# **Environmental Assessment Bear Creek Reservoirs Land Management Plan**

## **FINDING OF NO SIGNIFICANT IMPACT (FONSI)**

### **BEAR CREEK RESERVOIRS LAND MANAGEMENT PLAN FRANKLIN, MARION, AND WINSTON COUNTIES, ALABAMA**

Figure SRXB-A.3-1: EPU Power/Flow Map with ICA Regions

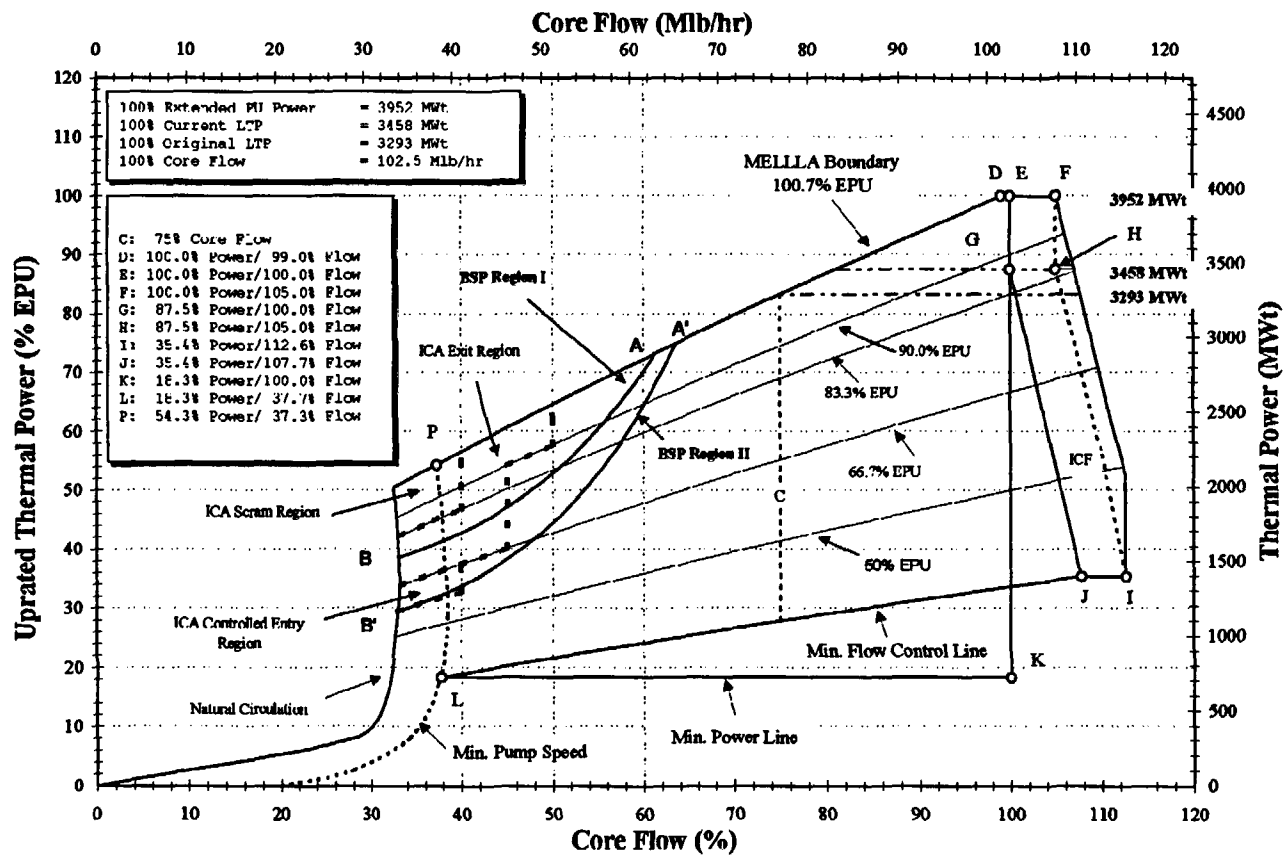
In Section 2.3.1 of the PUSAR, the thermal hydraulic instability exclusion regions are not shown in Figure-2-1. Provide a figure showing the instability exclusion regions.

The thermal-hydraulic exclusion regions are part of the backup stability method used when the Option III system is not operable. Backup Stability Protection (BSP) regions will be established as part of the reload licensing process on a cycle-specific basis in accordance with the guidance provided in

OG02-0119-260, "Backup Stability Protection (BSP) for Inoperable Option III Solution", dated July 17, 2002. Figure SRXB-A.3-1 provides a representation of the BSP regions for reduced feedwater temperature conditions. The original ICA regions, rescaled for EPU conditions, are also shown on this figure for comparison. Normal feedwater temperature BSP regions are typically smaller and the actual size of the BSP regions will vary for each operating cycle.
